ADDENDUM No. 3

RFP NO.: 616-008

PROJECT TITLE: Physical Education Building
 Exterior Renovations
 Germantown Campus

Item 3-1: Changes were made to the Construction Documents in response to architectural life safety and electrical review comments received from the Montgomery County Department of Permitting Services (MCDPS). Revised drawings are being reissued in their entirety in response to these comments and are attached to this addendum. Revisions are clouded, noted as “Permit Response Set” and dated 2/22/2016 in the title block on each sheet accordingly.

E201

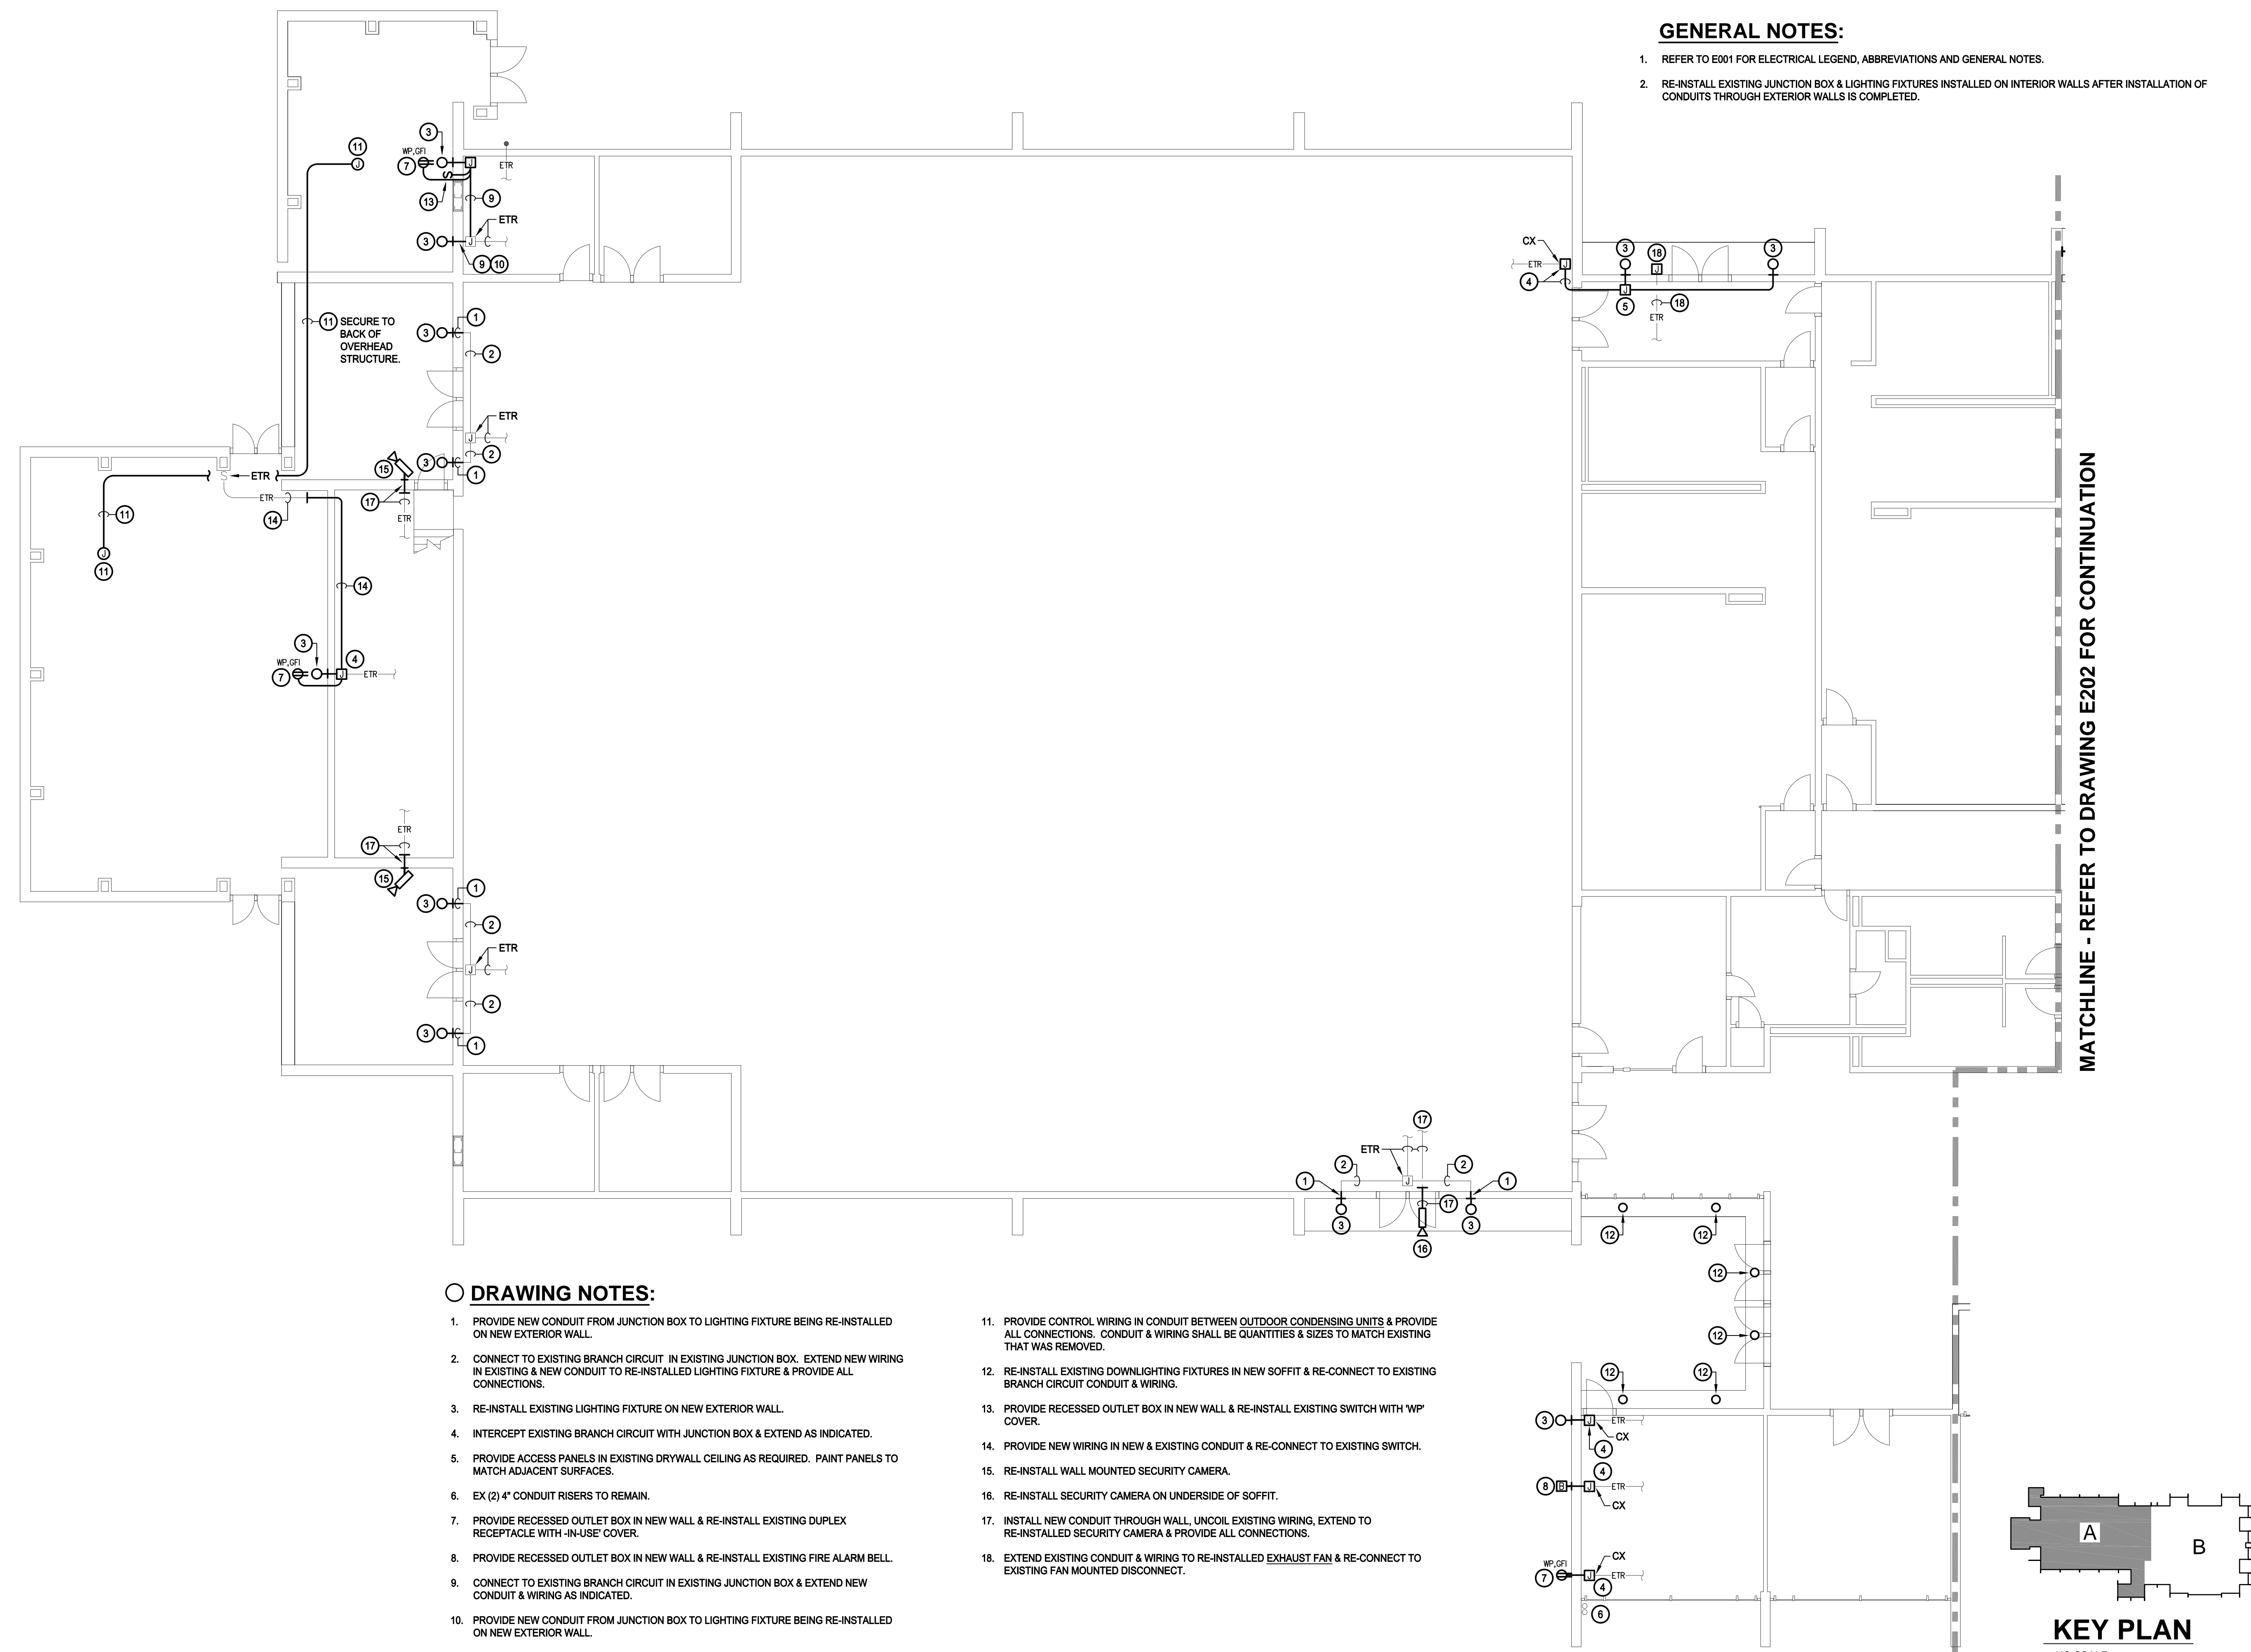
The electrical drawings show the work needed to remove all electrical devices from the exterior walls of the building, extend conduit and wiring (of same type and quantity), and reinstall the conduit and wiring on the inside surface of the exterior wall with the existing devices being reinstalled on the exterior wall in the same location. This work is merely an in-kind removal and re-installation of devices. The only new work included in this project is the addition of a 120V, 20A branch circuit for a power operated door which is shown on Drawing E202.
